**FINAL DRAINAGE  
REPORT**  
*for*  
**The Reserve at Hidden  
Lake Subdivision**  
**Vanderburgh County, Indiana**

**Project No.: 8716.4.002-B**  
**September 03, 2014**

**Re:** The Reserve at Hidden Lake Subdivision  
Our Project 8716.4.002-B

**Re - Construction  
 Basin # 2  
 Record Drawing**

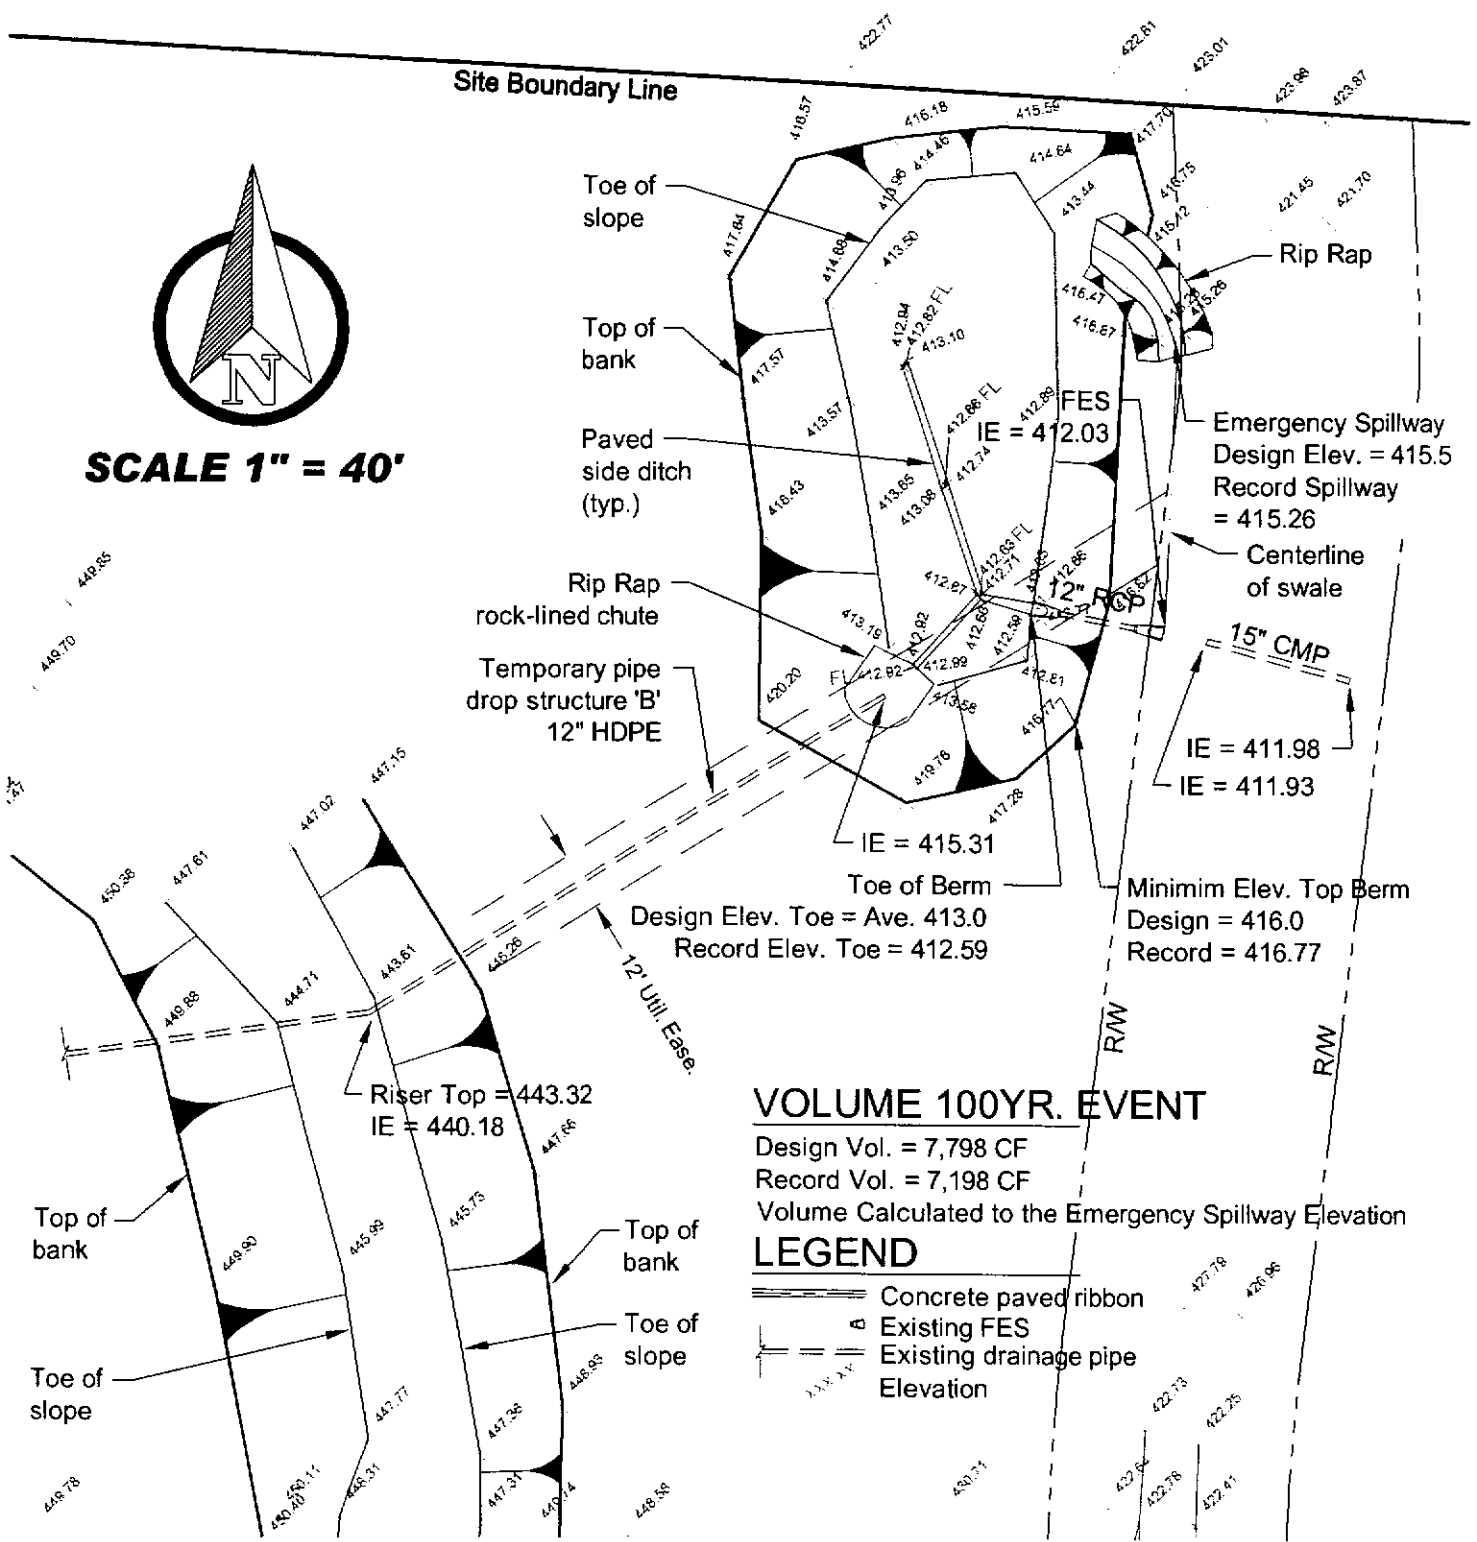
- Provide the existing elevations on existing storm drainage facilities so that we have a complete picture of what is going on
- Show the location of the emergency spillway of basin #2 as well as the swale data and emergency overflow data for this basin on the plans.

#2 The elevations and location of emergency spillway for existing Detention Basin #2 is indicated on Sheet C101 dated 10/13/14.
